COUNCIL ASSESSMENT REPORT

Panel Reference	2015SYW129
DA Number	DA-612/2015
LGA	Liverpool City Council
Proposed Development	Two residential flat buildings comprising one x seven storey building and one x six storey building with a total of 140 units, underground car parking, demolition of structures, and site works.
Street Address	28 Shepherd Street, Liverpool
Applicant/Owner	Applicant - Coronation (28 Shepherd St) Pty Ltd Owner - Calistan Pty Ltd
Date of DA lodgement	3 July 2015
Number of Submissions	Nil
Recommendation	Approval, subject to conditions
Regional Development Criteria (Schedule 4A of the EP&A Act)	The proposal has a capital investment value of over \$20 million, the Sydney South West Planning Panel is therefore the determining authority.
List of all relevant s79C(1)(a) matters	<ul style="list-style-type: none"> • <i>List all of the relevant environmental planning instruments: s79C(1)(a)(i)</i> <ul style="list-style-type: none"> • Contaminated Land Management Act 1997. • Water Management Act 2000. • State Environmental Planning Policy No.65 – Design Quality of Residential Apartment Development. • State Environmental Planning Policy No.55 – Remediation of Land. • State E

Figure 18: Amended basement level to address foreshore building line (source Woods Bagot)

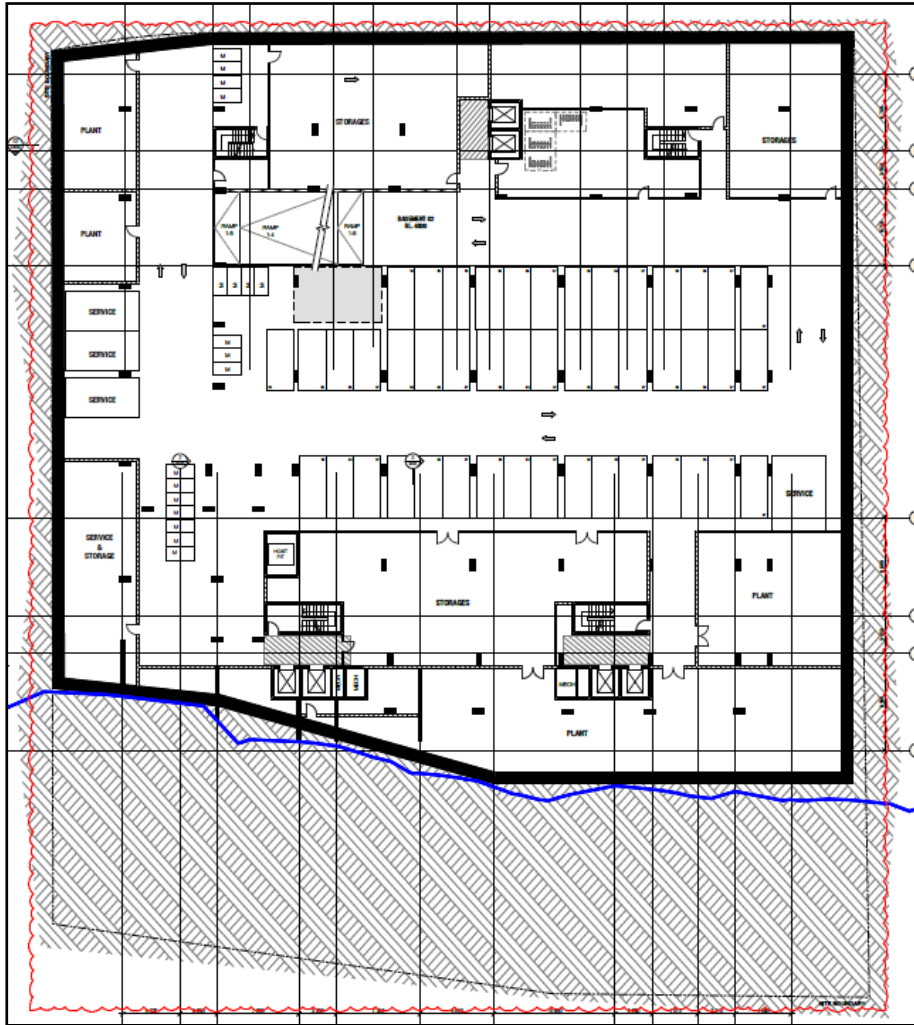
- The river-fronting façade of Building C1 has been stepped back towards Shepherd Street, to ensure no elements are within the Inner Vegetated Riparian Zone. This set back is gradually reduced in the upper levels, resulting in a cantilevered building element.
- A resulting reduction in apartment numbers to a total of 140, with alterations and reconfiguration of the apartments in Building C1 fronting the Georges River.
- A reduction in total gross floor area to 11,968m², representative of a floor space ratio (FSR) of 2.03:1.
- A revised apartment mix of:
 - 38% x 1 bedroom
 - 56% x 2 bedroom
 - 5% x 3 bedroom
 - 1% studio
- Basements 1 and 2 have been set back 20m from the highest bank measurement, whilst Basement 3 has been set back 40m from the highest bank measurement. This results in a revised car parking provision of 161 spaces.
